Subject: 13 Iluka Road Palm Beach NSW 2108 DA 2021/0197 WRITTEN
SUBMISSION: LETTER OF OBJECTION #2 Submission: Dennison-Quirk

SUBMISSION: DENNISON – QUIRK
a written submission by way of objection to DA 2021/0197

Re:
13 Iluka Road Palm Beach NSW 2108
DA 2021/0197

WRITTEN SUBMISSION: LETTER OF OBJECTION #2
Submission: Dennison-Quirk

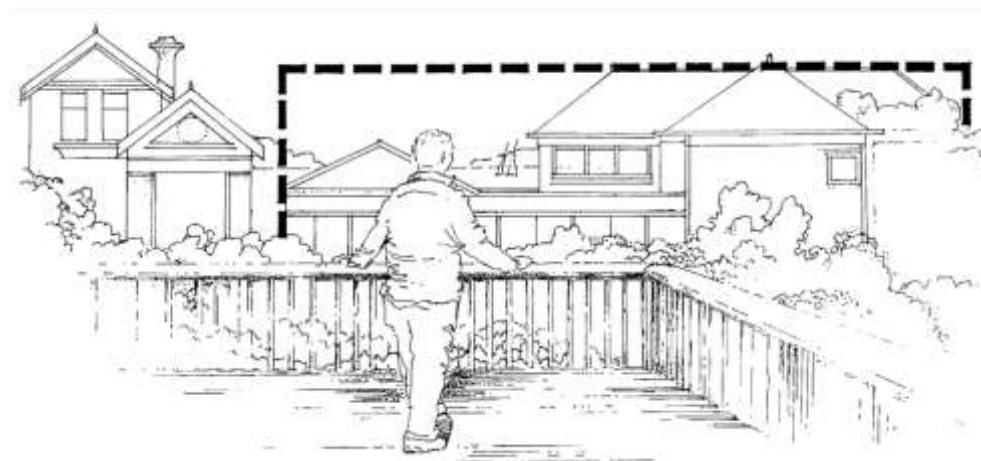
The planning principle states that consideration should be given to the causes of the visual impact and whether they are reasonable in the circumstances.

The fourth step is to assess the reasonableness of the proposal that is causing the impact. A development that complies with all planning controls would be considered more reasonable than one that breaches them. Where an impact on views arises as a result of non-compliance with one or more planning controls, even a moderate impact may be considered unreasonable. With a complying proposal, the question should be asked whether a more skilful design could provide the applicant with the same development potential and amenity and reduce the impact on the views of neighbours. If the answer to that question is no, then the view impact of a complying development would probably be considered acceptable and the view sharing reasonable.

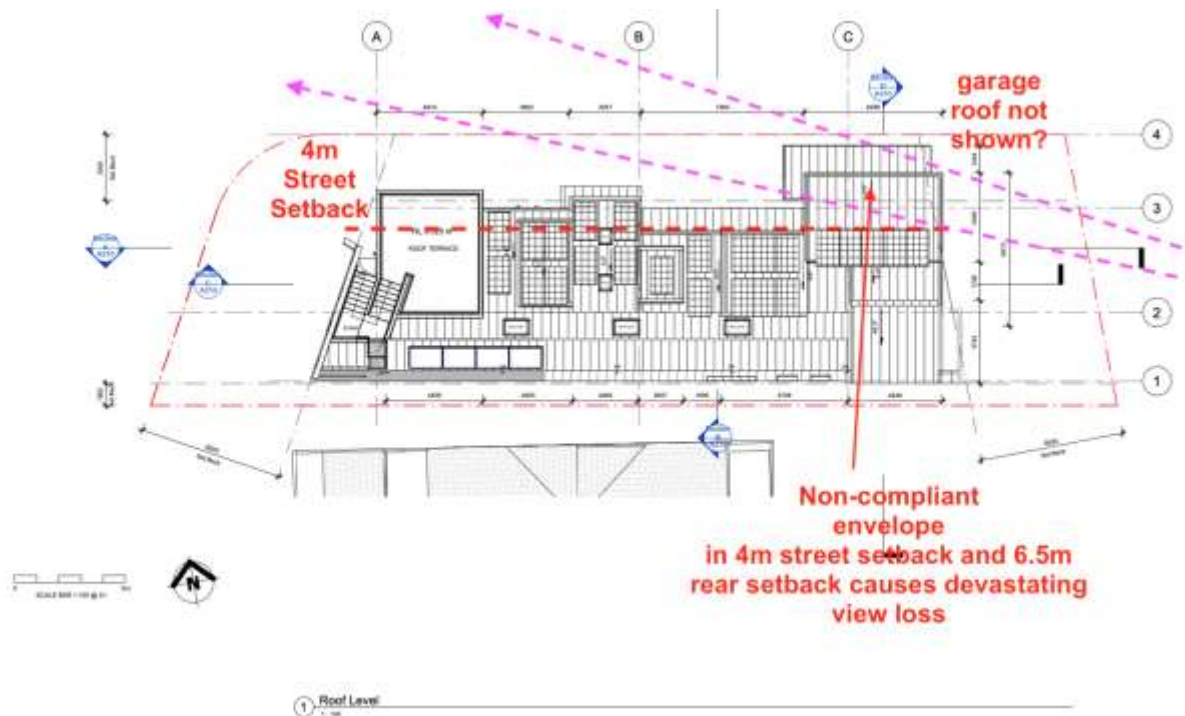
The private domain visual catchment is an arc to the west from which views will be affected as a result of the construction of the proposed development.

The proposed development will create view loss in relation to our property.

The views most affected are from living areas and associated terraces and include very high scenic and highly valued features as defined in Tenacity.

Having applied the tests in the Tenacity planning principle and without height poles erected, we conclude that we would be exposed to a devastating view loss.

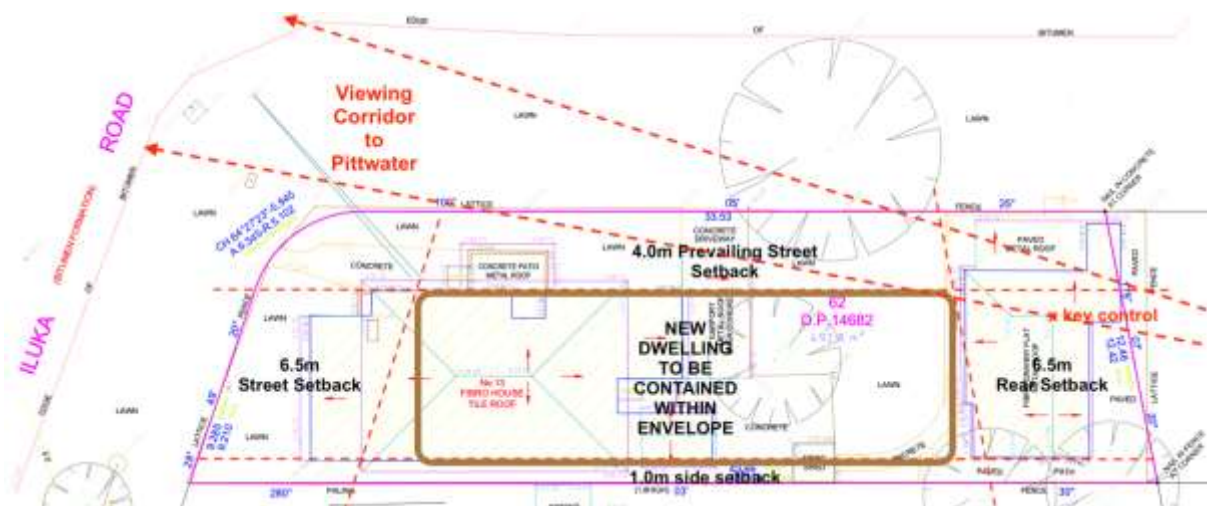
A proper site analysis on view loss would have defined a zone where built form could be considered to ensure that the water view was shared. We attach a marked-up analysis that shows the area in red, that a two-storey development could be considered that would protect that view. This identifies a considerable zone that is open for the Applicant to develop within, without causing a devastating view loss outcome.

The 'key control' to avoid the devastating view loss is located on the attached marked up survey drawing. The northern end of the roof of the existing Granny Flat is the location from which the view is lost in an arc from the west to the north-west. A compliant 6.5m rear setback, coupled with a compliant 4.0m prevailing street setback, being the existing main dwelling on the subject site, would maintain the view. Any proposed development would need to be tested by a 'height pole' at the 'key control', and preferably prior to any redesign commencing to better inform the design outcome.

We state that there is ample area for a two-storey development on the subject site, as defined by the above site analysis, showing a considerable zone for built form over two levels. With good design, there is scope for view sharing to occur while also providing for reasonable floor space on both levels.
